BROCK FOURTH ADDITION

Re: S/D 97-23 - BROCK 4TH ADDITION (Final Plat)

Re: S/D 97-23 - BROCK 4TH ADDITION (Final Plat)

CASE NUMBER: S/D 97-23 - **LINDA WINTERS ADDITION**

FINAL PLAT

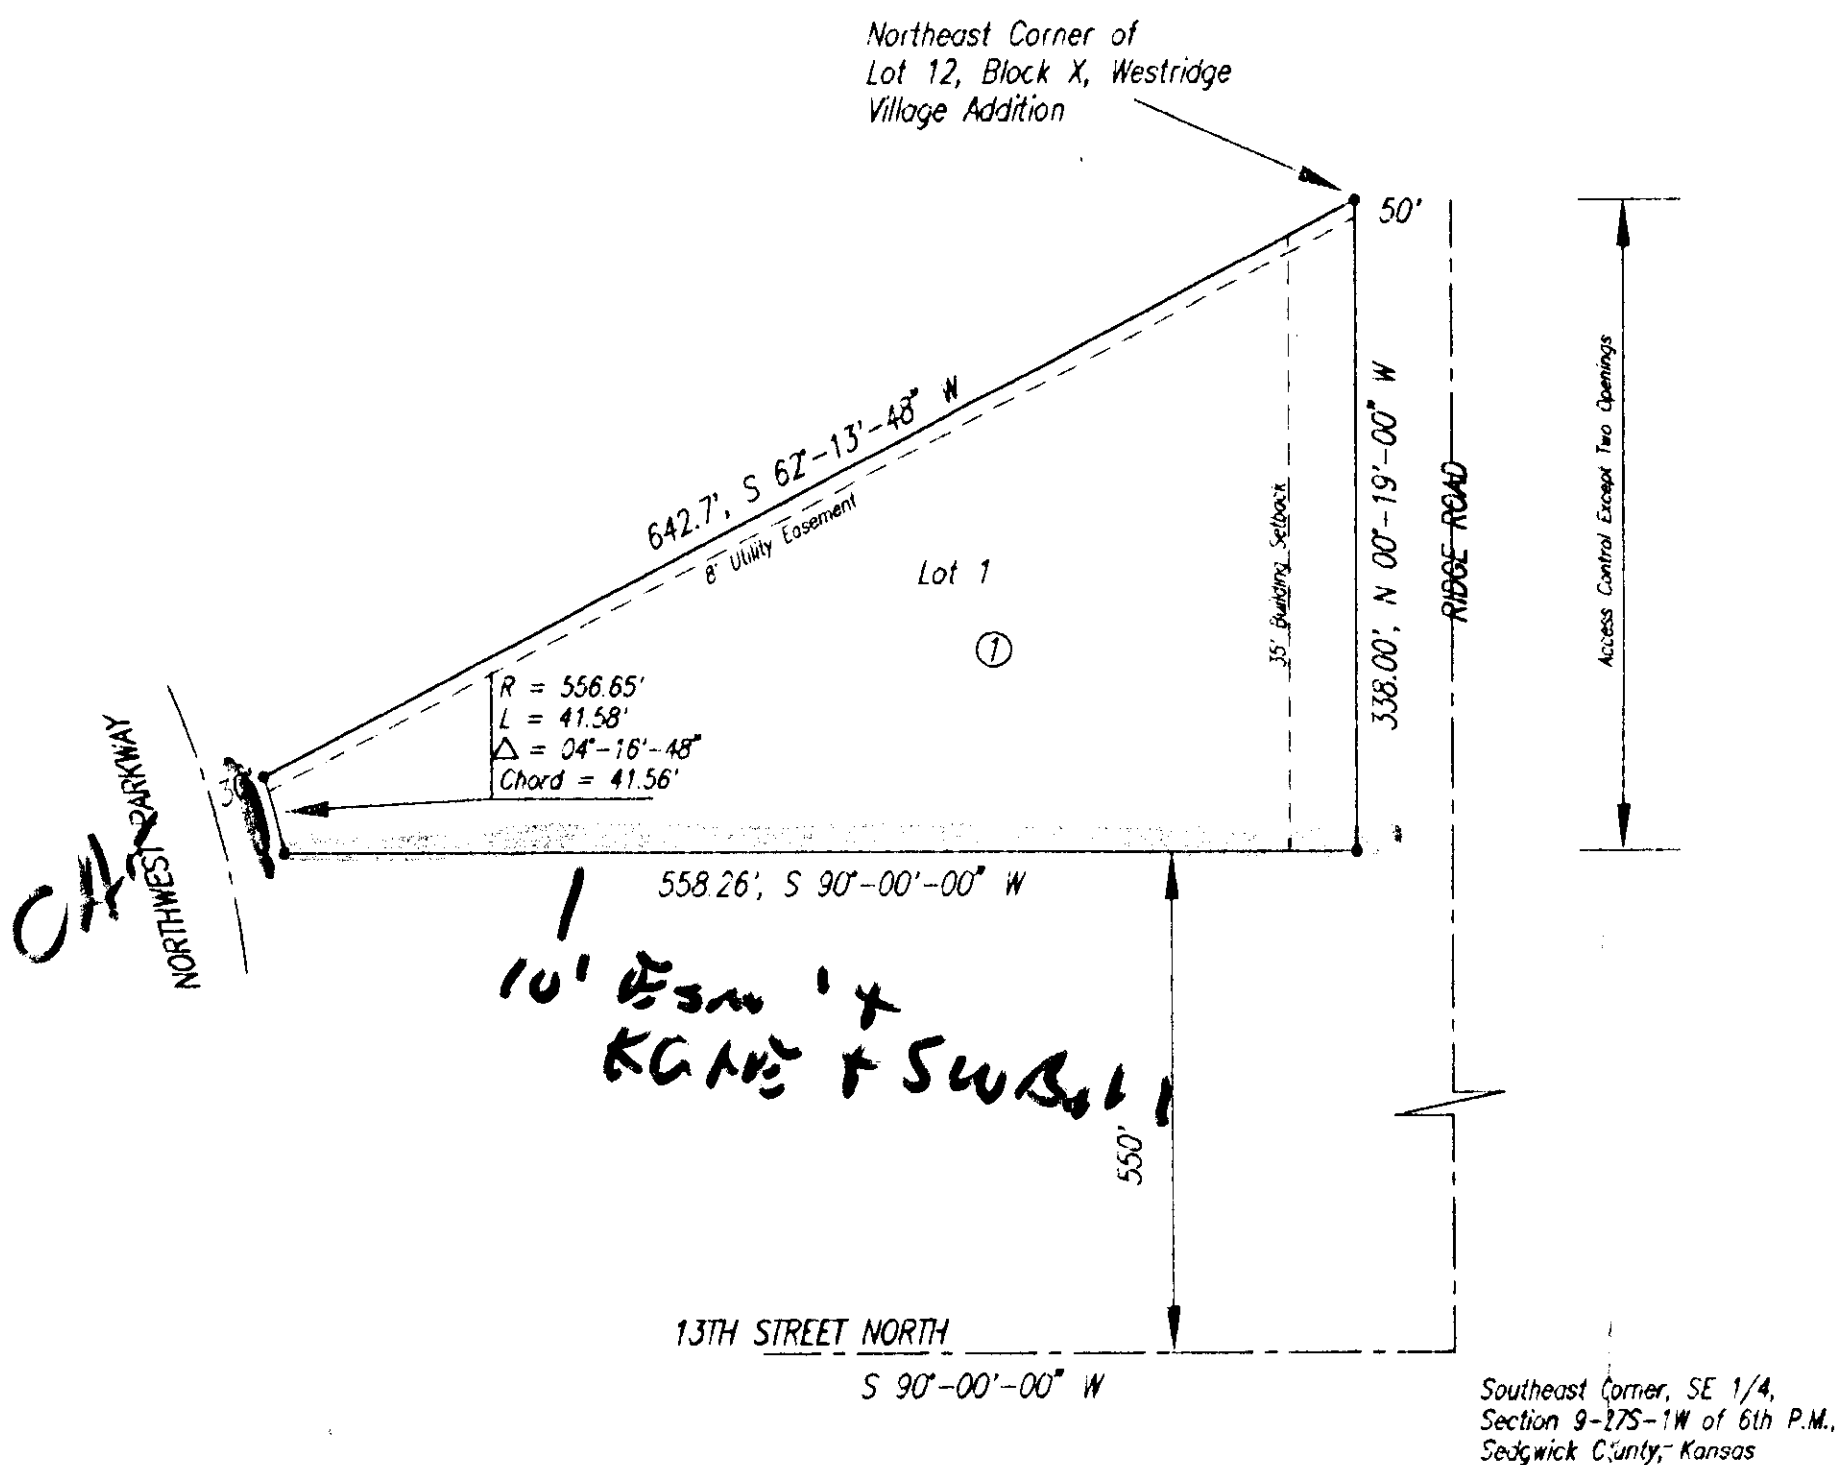
- A. This plat shall be subject to approval of the associated zoning case (Z-3222) and any relevant conditions involving the platting of the site per the zone case.

- B. The applicant shall guarantee any drainage improvements required by the platting of this property. Such improvements (private storm sewer) may be done at the time of site development.

- C. On the final plat tracing, complete access control shall be shown to Northwest Parkway. Also, only one access opening shall be indicated to Ridge Road. Both the face of the plat and platter's text shall note this access control. The platter's text shall also be amended to use the standard terminology for the dedication of access controls to the City of Wichita and that the location of any opening (to Ridge) is subject to approval by the City Engineer.

- D. On the final plat tracing, the Deputy Register of Deeds shall be indicated as Michael D. Hurtt.
- E. If the dot symbols at the corner of this plat (lot) involve irons found, set, etc. this should be noted in a legend located below the north arrow.

- F. On the final plat tracing, the center line of Ridge shall be labelled "CL".
- G. The applicant shall install or guarantee the installation of all utilities and facilities which are applicable and described in Article 8 of the MAPC Subdivision Regulations. (Water service and fire hydrants required by Article 8 for fire protection shall be as per the direction and approval of the Chief of the Fire Department.)

- L. The final plat shall indicate the utility easements requested by K.G. & E. and Southwestern Bell which are indicated on the enclosed "marked" copy of the plat.

- M. As requested by the applicant, the final tracing may be submitted with a revised name. It should be noted that an Addition, now within Wichita, exists with the name Winter. While the use of Winters should be acceptable, it is recommended that a greater name distinction be used such as by adding a first initial, e.g., A. Winters, T. Winters, or so forth.
